**Article No.  
03-12-1**

- **ELECTRICAL - THINK NEIGHBOR - GAUGE INOPERATIVE OR INACCURATE - VEHICLE DOES NOT MOVE FORWARD OR REVERSE - VEHICLE DOES NOT CHARGE PROPERLY**

Publication Date: June 4, 2003

**THINK:** 2002 THINK NEIGHBOR

Figure 1 - Article 03-12-1

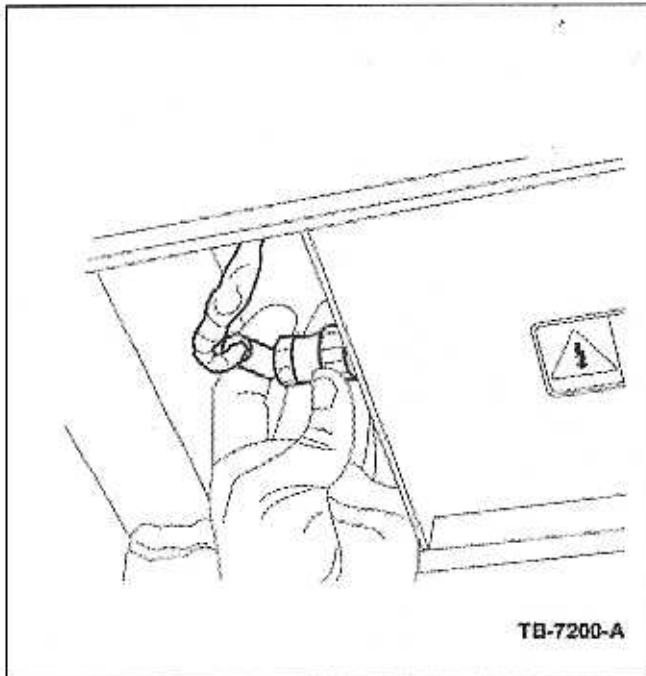
1. Remove the DC connection from the onboard charger as seen in [Figure 1](#).
2. Separate the back shell from housing as shown in [Figure 2](#). A description of the various parts of the DC connector is shown in [Figure 3](#).

Figure 4 - Article 03-12-1

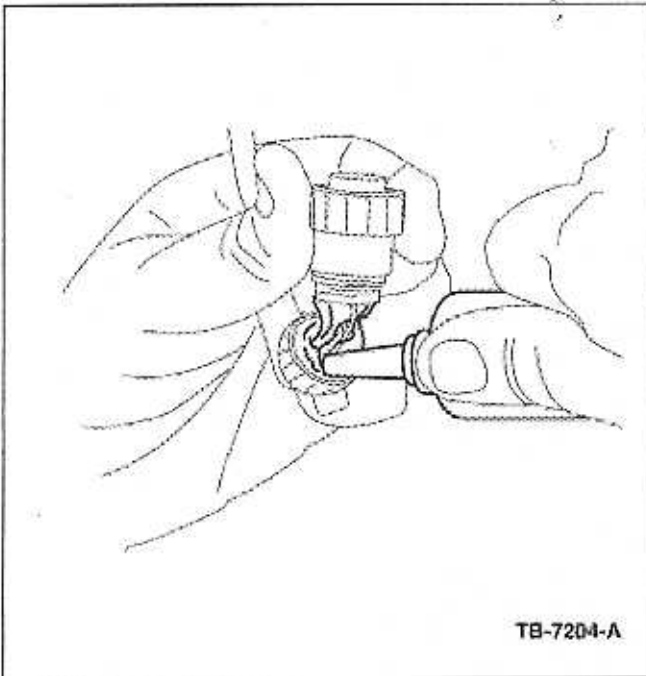
3. Saturate the area between the wires at the back of the housing with Clear Silicone Rubber F7AZ-19554-CA as shown in [Figure 4](#).
4. Fill the back shell with sealer as shown in [Figure 5](#). Connect the back shell and housing together, be careful not to twist wires going into the housing. Wipe the excess sealer away with a clean rag.

Figure 6 - Article 03-12-1

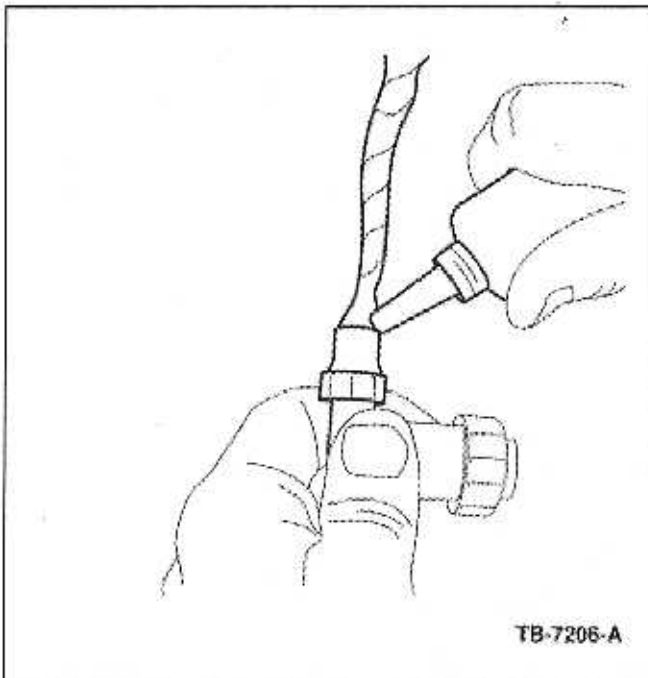
5. Squeeze sealer into the rear of the back shell as shown in [Figure 6](#). Tighten down the strain relief to the back shell. Wipe away any excess sealer with a clean rag.

Figure 8 - Article 03-12-1

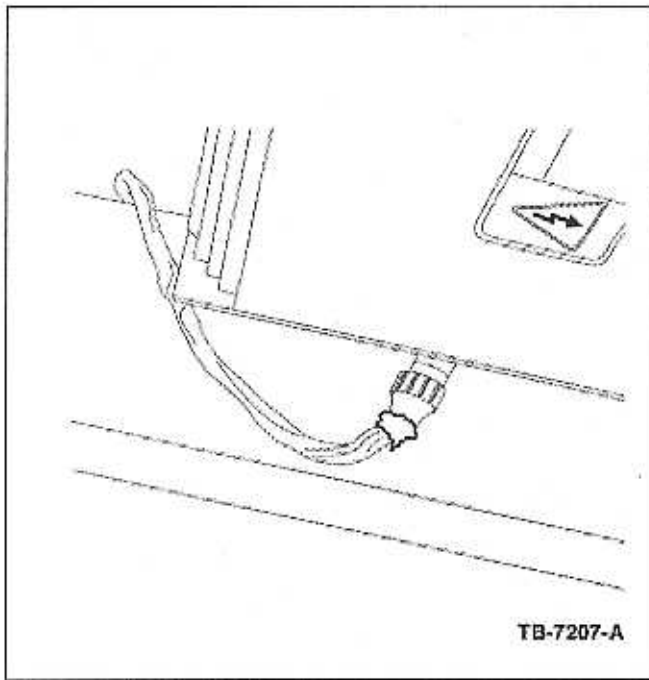
6. Squeeze sealer into the top of the strain relief as shown in [Figure 7](#). Wipe away any excess sealer with a clean rag.
7. Connect the DC connector to the onboard charger, make sure the coupling ring is secure to the on board charger. Position the connection in the down position as shown in [Figure 8](#). This can be performed by loosing the back shell from the housing, when the position is aligned, tighten back shell to the housing.

Figure 9 - Article 03-12-1

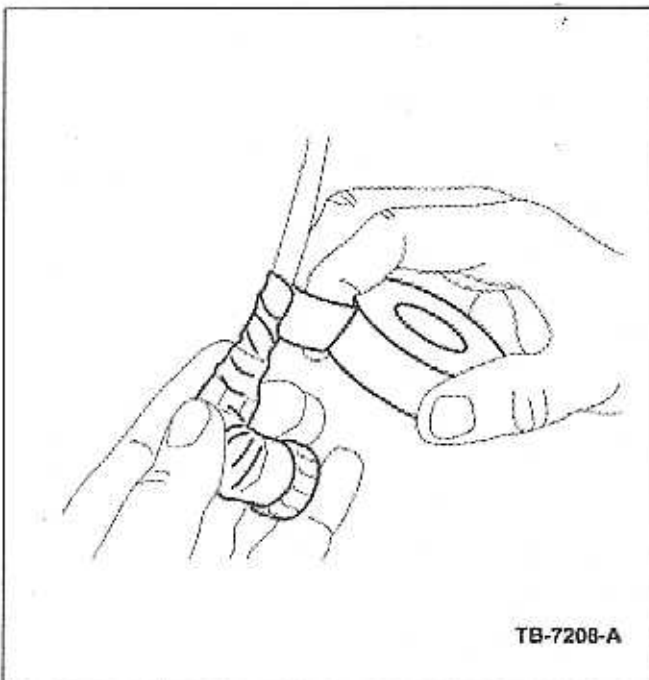
8. Remove the DC connection from the onboard charger and wrap electrical tape around the entire connector up to the coupling ring as seen in [Figure 9](#).

Figure 10 - Article 03-12-1

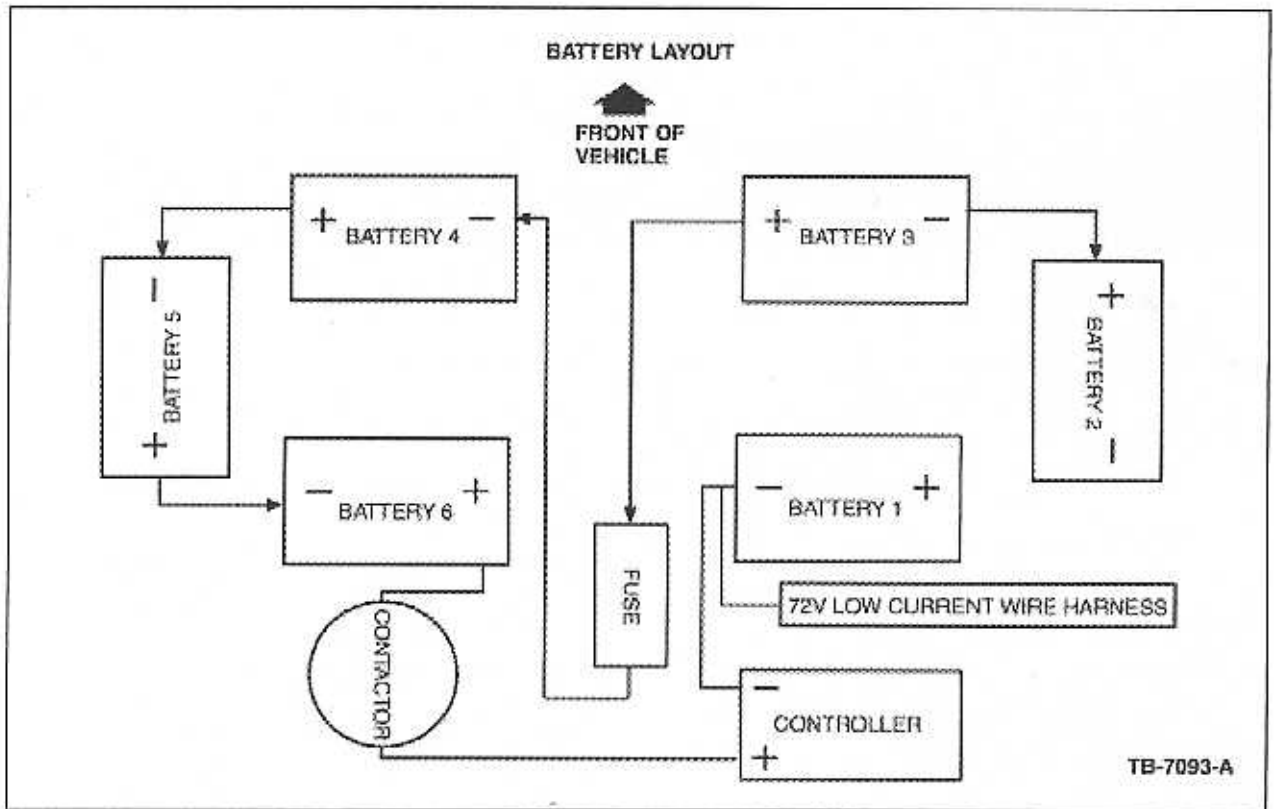
- j. Disconnect the battery cables between battery 2 & 3 and between battery 4 & 5, wrap the terminals on the cables with electrical tape. Battery location can be referenced at [Figure 10](#).
